FURTHER INFORMATION REQUEST / OUTSTANDING MATTERS

APPLICATION NO: MCUI/54/2024
PROPERTY ADDRESS: 210 PARK RIDGE ROAD, PARK RIDGE QLD 4125
PROPERTY DESCRIPTION: LOT 9 RP 97339
APPLICATION DESCRIPTION:
• **MATERIAL CHANGE OF USE - VARIATION REQUEST**

Figure 1: Extract of IC3 alignment regarding RL/102/2024

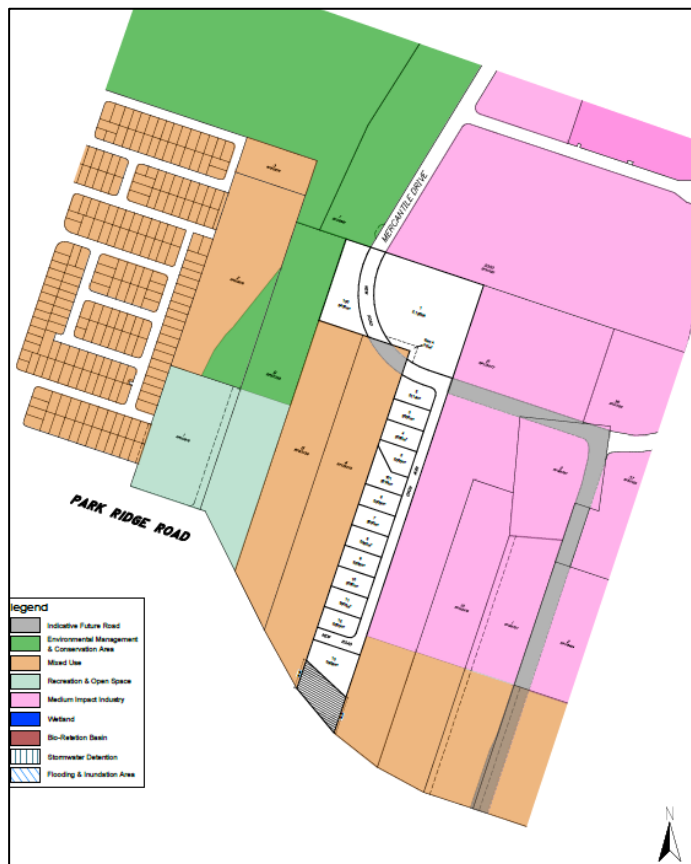
Given the assessment being carried out in relation to RL/102/2024, Council officers will be able to support an alignment for the IC3 which extends into the High flood risk area and waterway area. This is on the basis that the flow regime of this area will be changed by RL/102/2024, which is upstream and development to the east. Mercantile Drive is currently with RID for design and realignment and the structure plan for RL/102/2024 has been accepted by Council for the IC3 alignment.

The subject site will ultimately be required to access the development site via the internal road and temporarily via Park Ridge Road. This means any structure plan provided will need to show an internal road network that can be delivered extending from adjoining sites to the east.
